June 17, 2026**Addendum No. 02****File Reference Number: RFP 2026 031****Title: Cochrane Station Parking Lot Paving Project****RE: Clarifications/Questions**

APPENDIX H - ISSUE FOR TENDER DRAWINGS (ADDENDUM NO. 02)

DRAWING TITLE
LIGHTING LAYOUT

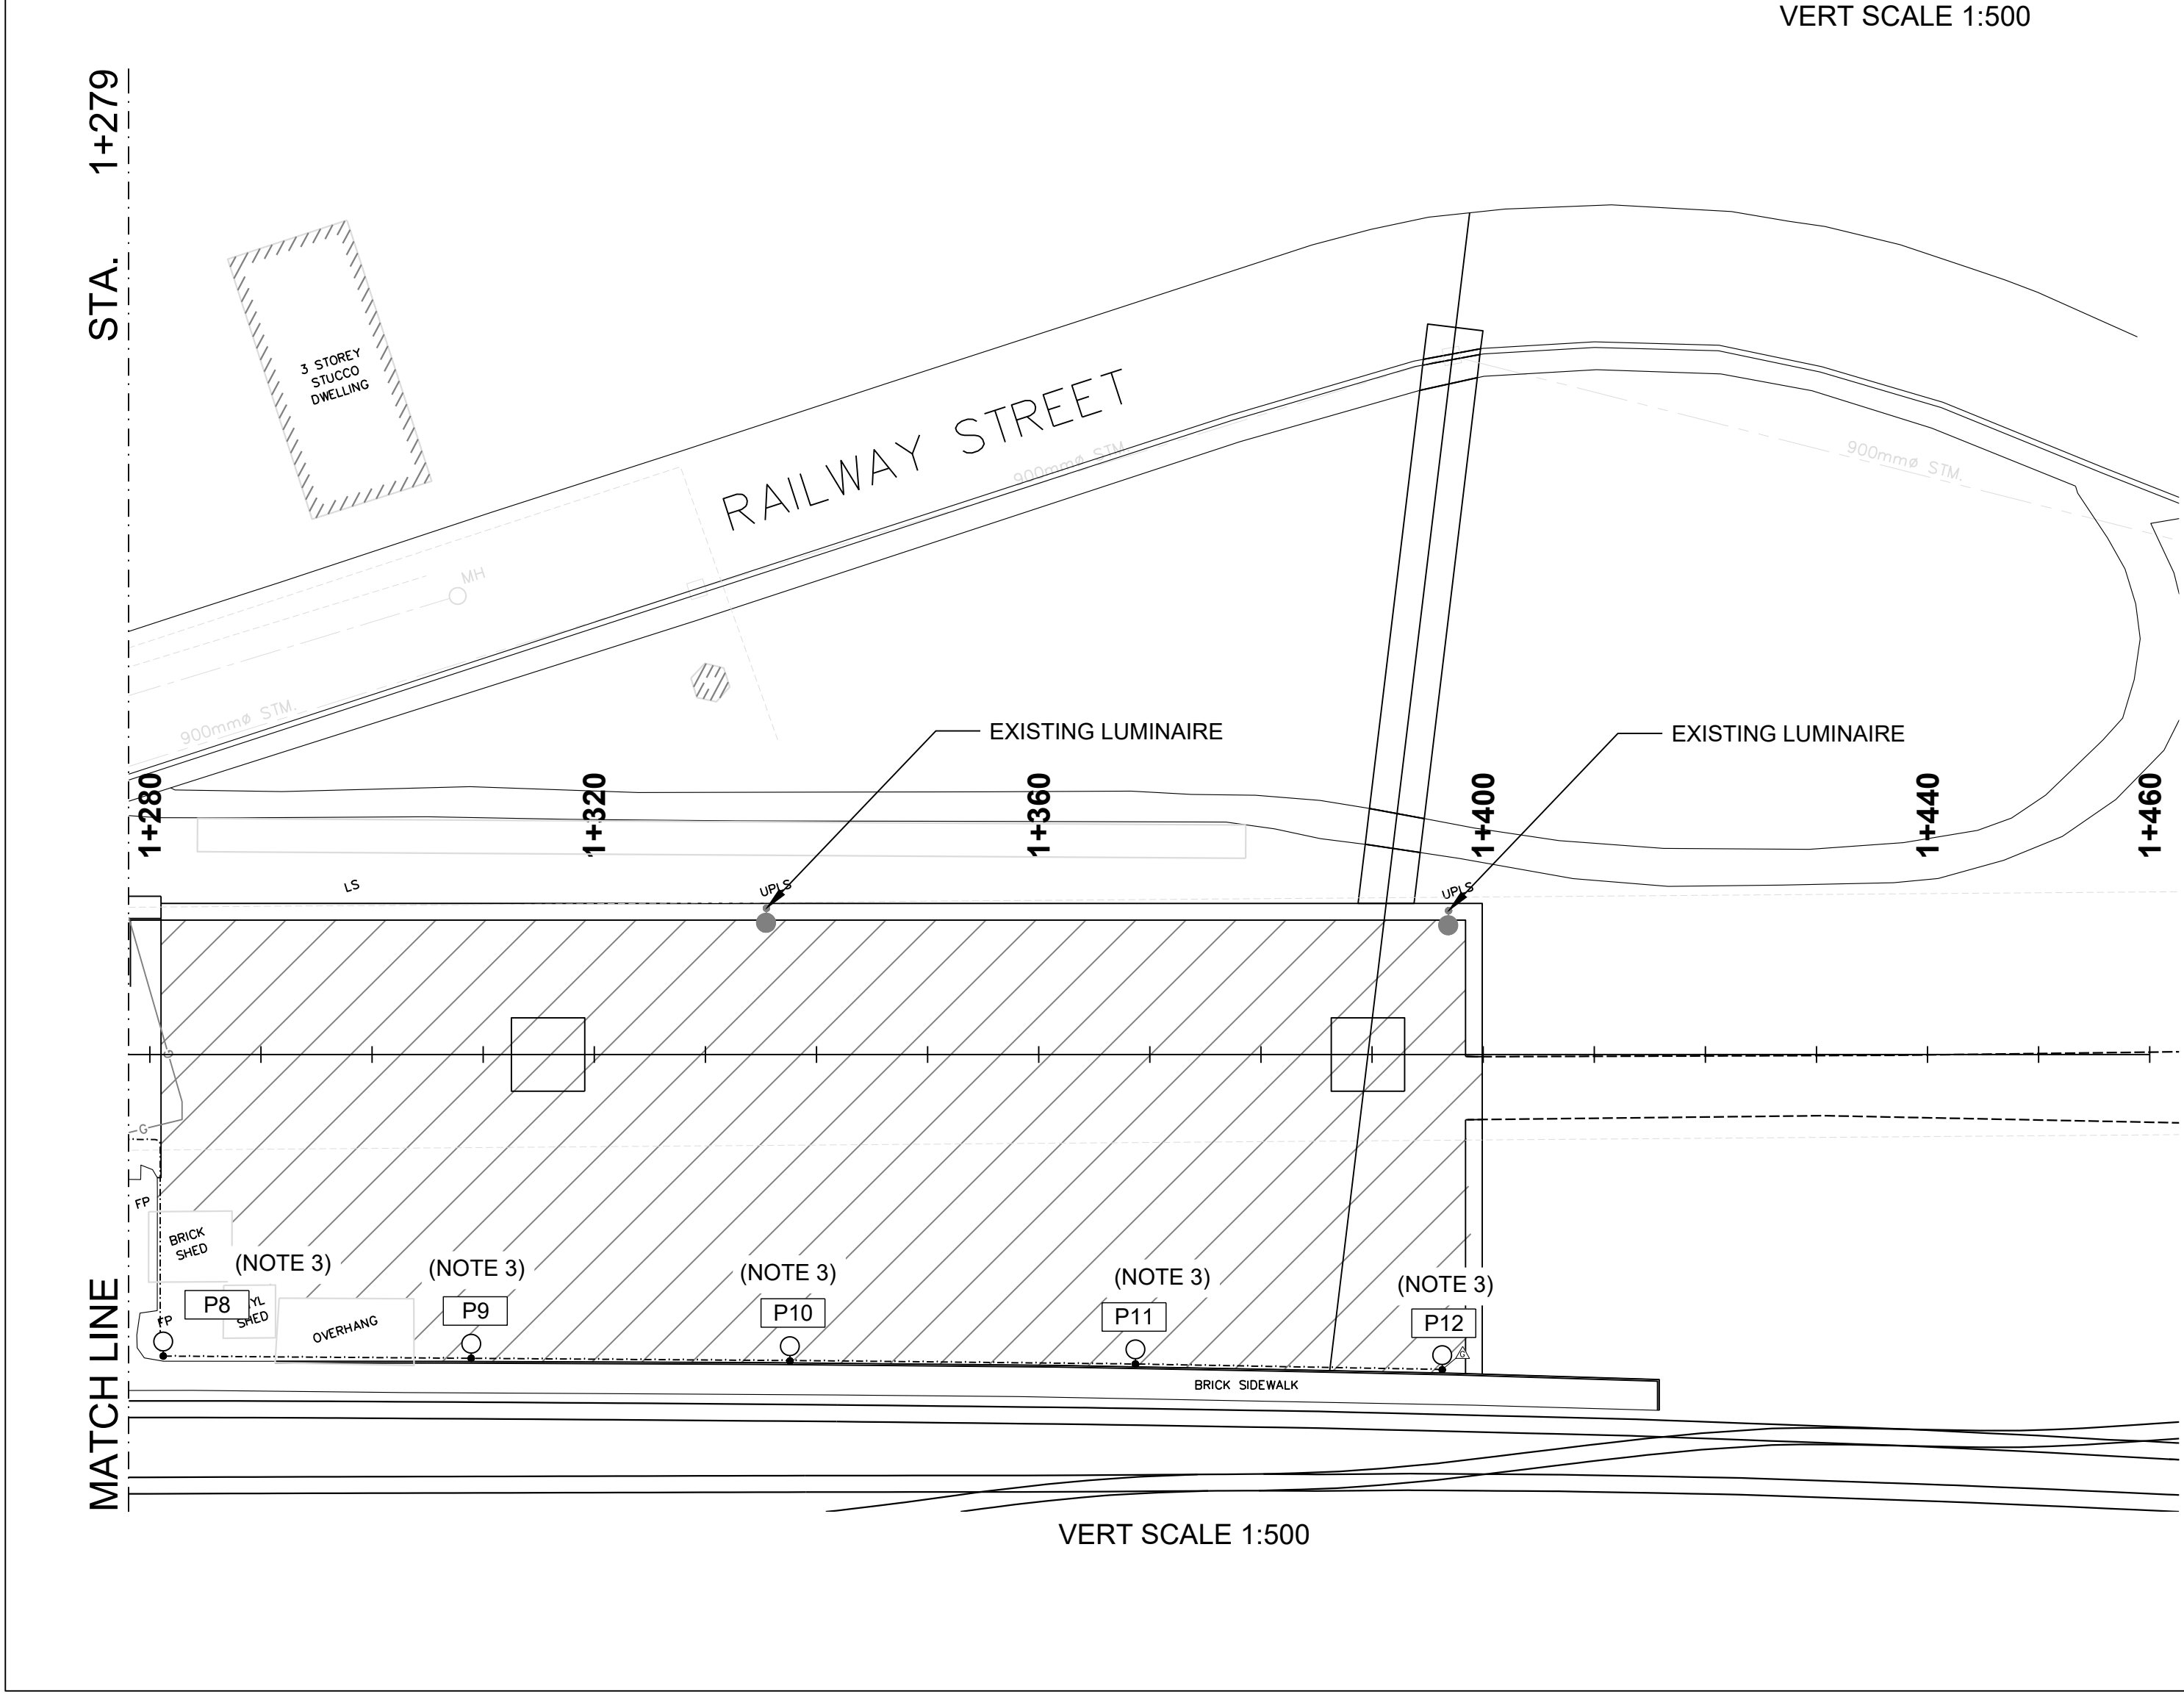
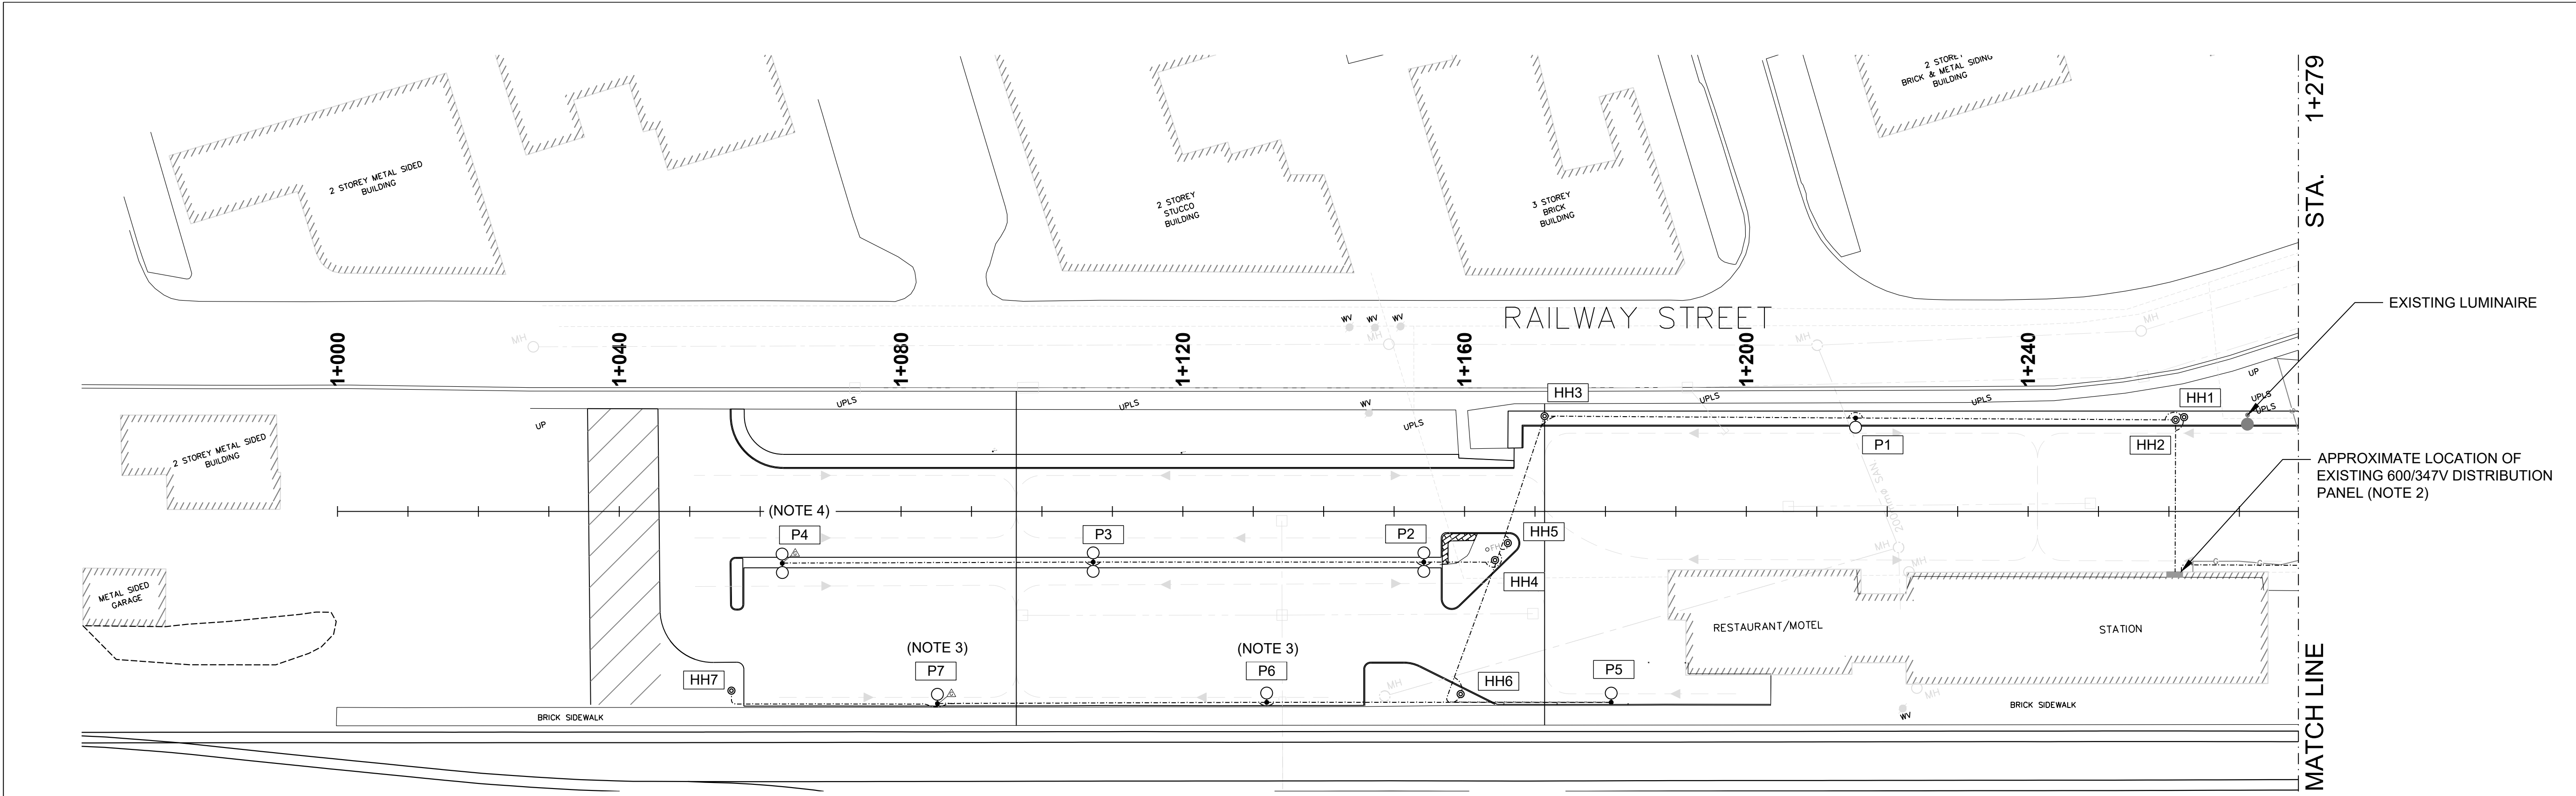
- Drawing E-102 has 9 each poles & 3 each handholes
- Item 65 and 66 are for 12 each concrete bases and poles
- Item 54 is for 8 each handholes

Answer: There are 12 NEW Lighting Poles to be supplied and installed. 8 Handholes are to be supplied, 5 for communications, 2 for lighting and 1 for the possible need of water meter location. The water meter location is by others. Appendix D – Schedule of Prices has been updated to reflect this and has been provided as a separate attachment to this Addendum No. 02.

Answer: Please be advised that the scales shown on the drawings are correct. However, when the drawings were stamped and scanned to PDF, a slight reduction in size occurred. The PDF has since been adjusted to restore the drawings to the correct scale.
